Access Compliance Report

Public Rights-of-Way

(Curb Ramps)

Intersection ID: 23574	Main Street: CARMEL_RD	Cross Street: QUAIL_HOLLOW_RD	Location: SW
ADA ID: 6C46887FEB54	Ramp Type: BlendTrans1	Initial Pass/Fail: Pass	Overall Compliance: No
		Severity Score: 2.5

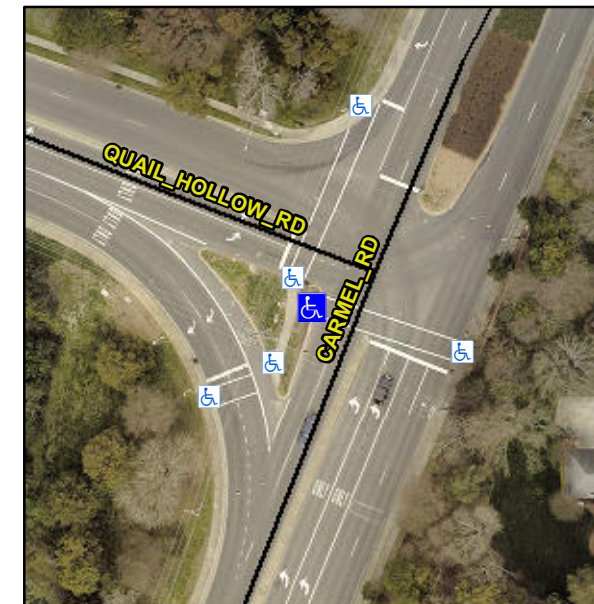
DAMAGED GTR

R304.2.2-Perp, R304.3.2-Para, R305.1.4, R305.2

Remove & Replace Curb Ramp With Two New Directional Ramps or Equivalent.
